<b>Title - Sujet</b> Repairs Ateliers-Canal-de-Lachine	
<b>Solicitation No. - N° de l'invitation</b> EE520-210288/A	<b>Amendment No. - N° modif.</b> 002
<b>Client Reference No. - N° de référence du client</b> R.101200.001	<b>Date</b> 2020-09-18
<b>GETS Reference No. - N° de référence de SEAG</b> PW-\$MTC-775-15834	
<b>File No. - N° de dossier</b> MTC-0-43063 (775)	<b>CCC No./N° CCC - FMS No./N° VME</b>
<b>Solicitation Closes - L'invitation prend fin at - à 02:00 PM on - le 2020-10-01</b>	<b>Time Zone Fuseau horaire</b> Heure Avancée de l'Est HAE
<b>F.O.B. - F.A.B.</b>	
<b>Plant-Usine:</b> <input type="checkbox"/> <b>Destination:</b> <input type="checkbox"/> <b>Other-Autre:</b> <input type="checkbox"/>	
<b>Address Enquiries to: - Adresser toutes questions à:</b> Aguilera, Maria Pia	<b>Buyer Id - Id de l'acheteur</b> mtc775
<b>Telephone No. - N° de téléphone</b> (514) 592-3823 ( )	<b>FAX No. - N° de FAX</b> (514) 496-3822

Amendment 002:

## ADDENDUM PAGEAU MOREL NO. 1

DÉTAIL EN COUPE - DETAIL DE ÉVENT DE VENTILATION / VENTILATION VENT DETAIL

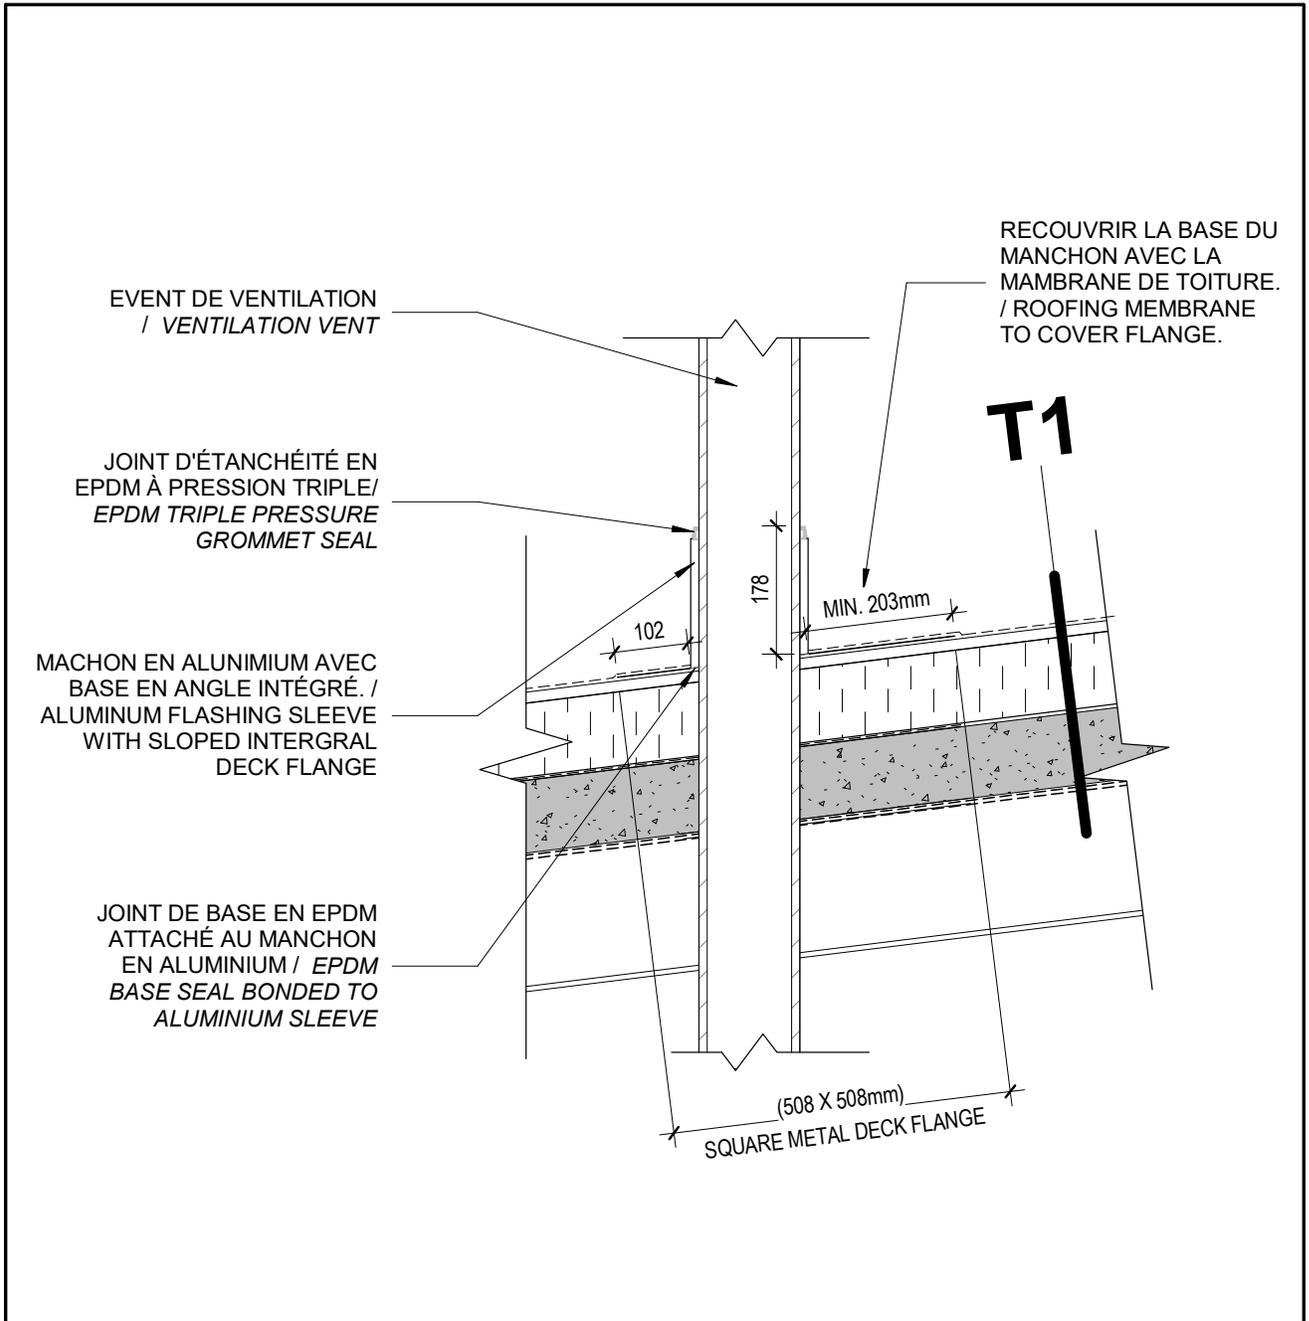
- .1 A004 SITE PLAN
  - .1 Replace the drawing *Issued for tender* issued on August 7, 2020 by the attached drawing *Issued for Addenda A01* dated September 16, 2020.
- .2 A512 DETAILS – DOORS, WINDOWS & FRAMES
  - .1 Add detail 3/A512, refer to attached sketch ASK01 dated September 16, 2020.
